Title: Advisory Committee on Reactor Safeguards  
Plant License Renewal Subcommittee

Date: Tuesday, September 30, 2003

UNITED STATES OF AMERICA  
 NUCLEAR REGULATORY COMMISSION  
 + + + +  
 ADVISORY COMMITTEE ON REACTOR SAFEGUARDS  
 PLANT LICENSE RENEWAL SUBCOMMITTEE  
 + + + +  
 H.B. ROBINSON STEAM ELECTRIC PLANT, UNIT 2  
 + + + +

# RNP-SB0 Offsite Power Recovery

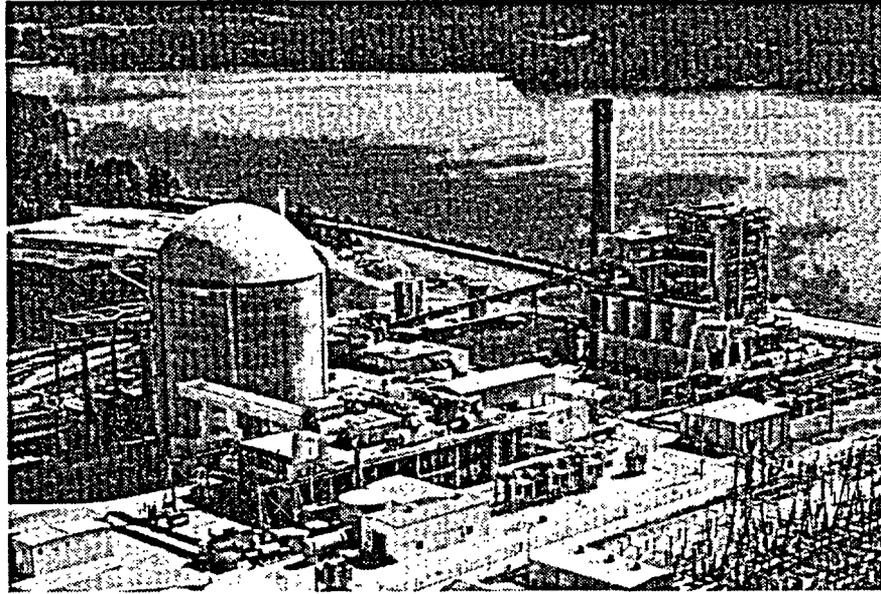
18 MR. ROSEN: Now before you get off this  
19 slide, this is where my question was, about  
20 Building 175, which is the switch yard relay  
21 building, and the switch yard and transformer  
22 itself. Are they now all in scope?

20 MR. ROSEN: Maybe if you step up to the  
21 diagram and show us what's in scope and what's not.

18 MR. ROSEN: Okay. So your normal piece  
19 on the Unit 1 slide, and that has now got two  
20 breakers and some associated bus that are in scope  
21 for license renewal for the nuclear plant.

9 MR. HEATH: No, they're all together.  
10 There's one switch yard. The Unit 1 side feeds  
11 into the 115 KB. The Unit 2 side feeds into the  
12 230 KB. It's all one switch yard. Typically  
13 though, that's the separation, just which plant is  
14 normally connected to which switch yard, which set  
15 of the 115 KB or 230 KB. In other words, Unit 1  
16 could shut down and it would make no difference to  
17 Unit 2, as far as that switch yard is concerned.
